**Drain:** BENTLEY OAKS 24"  
**Improvement:** Bentley Oaks SCL 1  
**Operator:** JIM SNOUFFER / JARED LIVINGSTON  
**Date:** 9-18-03  
**CLASS** URBAN  
**YEAR CONST** 1991 ASB014 ID 114-0450

RE: Bentley Oaks Drain

**Re: Bentley Oaks Drain - Sec. 1 Arm**

**Re: Bentley Oaks Drain: Sec. 1 Arm (Revised Final Report)**

PROFILE PLOTTED  
 NOTE BOOK  
 NO. OF SHEETS  
 NO. OF SHEETS

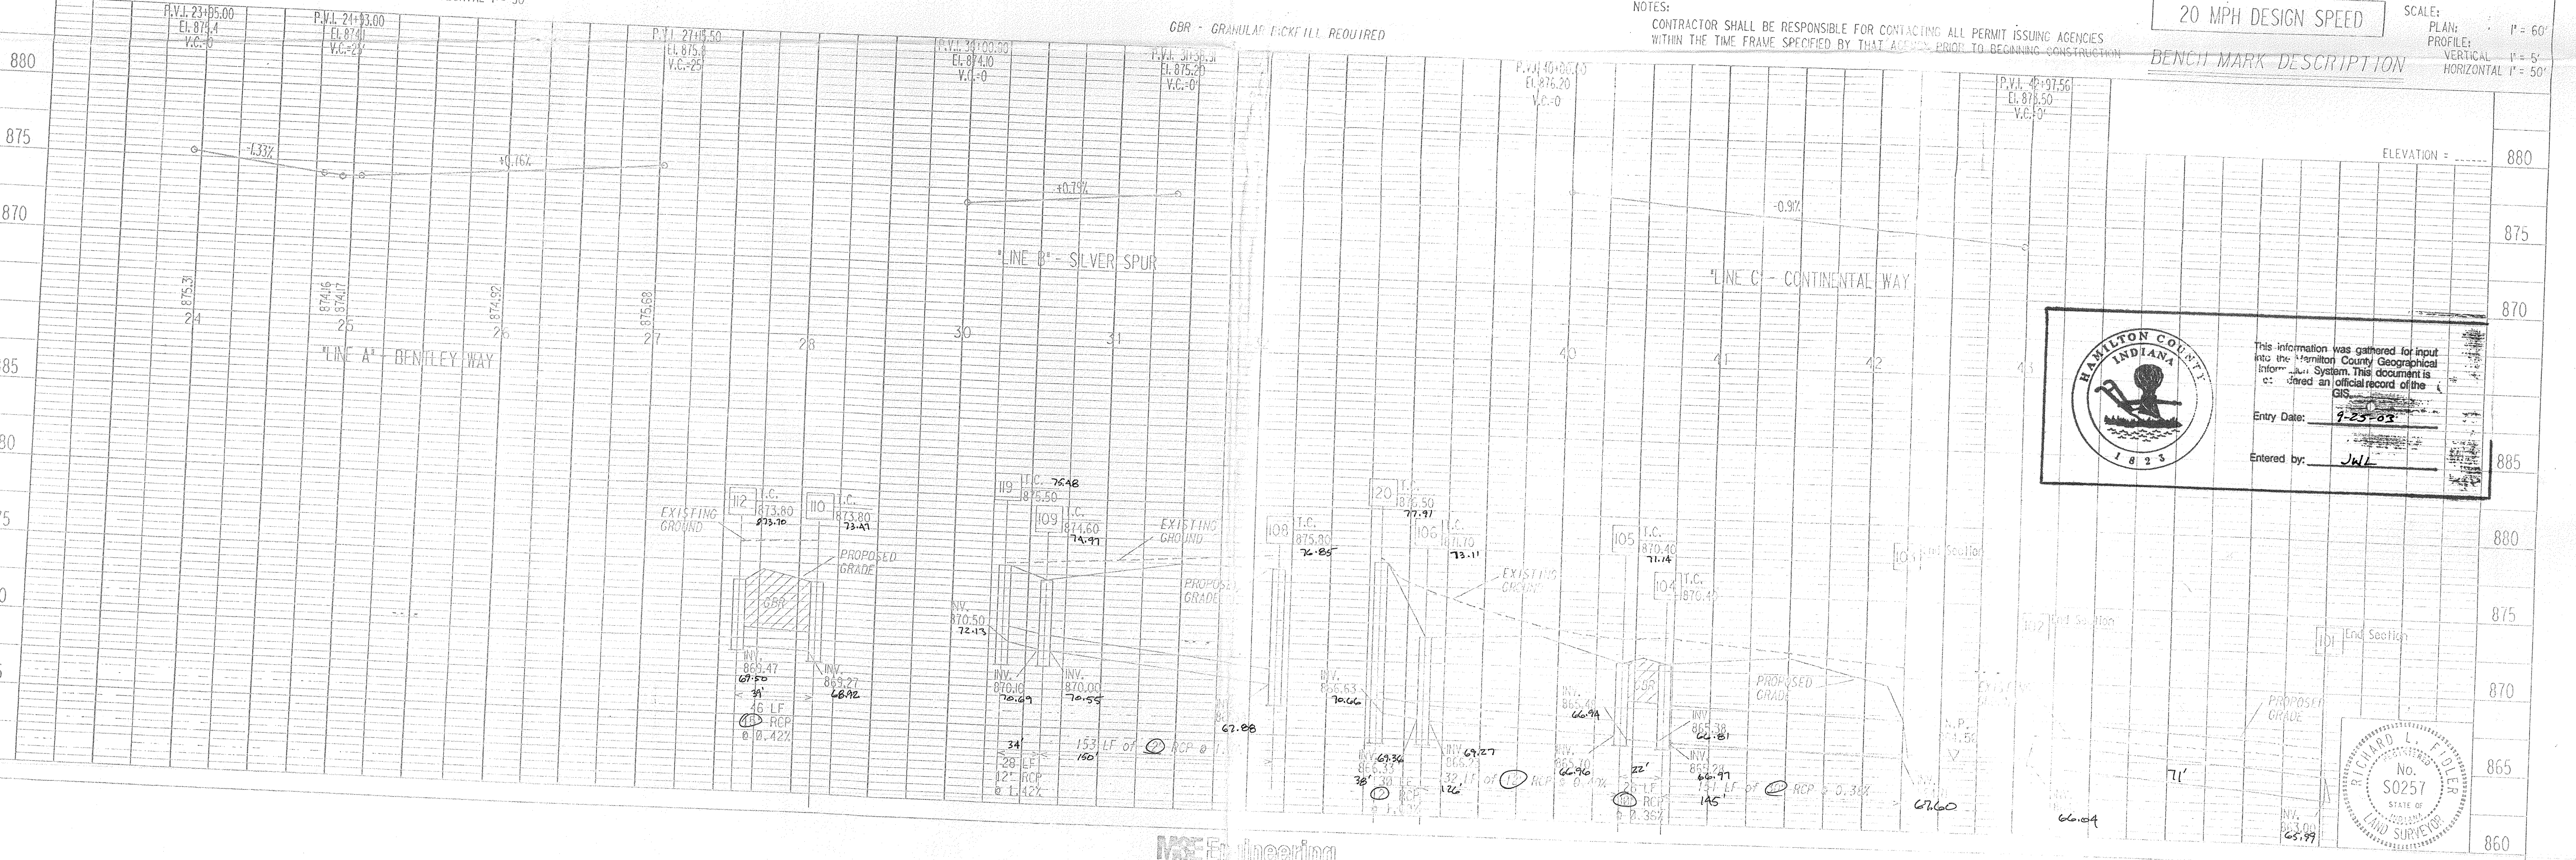
\* Digitize/Rectify 6" SSD ✓

\* STR 102-101 - needs new feature (storm instead of SSD) ✓

\* digitize pond ✓

\* STR 108-110 Label 24" ✓

STR 115-117 Label 12" ✓

STR 107 - needs removed - street pipe from 108-105 31' - 30" RLA ✓

\* digitize SSD under curbs & put lengths for rear yard SSD ✓

During construction, changes were made to the drain which will alter the plans submitted with my report for this drain dated February 11, 1992. The changes are as follows: The 12" RCP is now 872.34' feet. The 15" RCP is now 110.66' feet. The 18" RCP is now 335.89' feet. The 24" RCP is now 159.91' feet. The 30" RCP is now 698.35 feet. Structure 107 was not constructed.
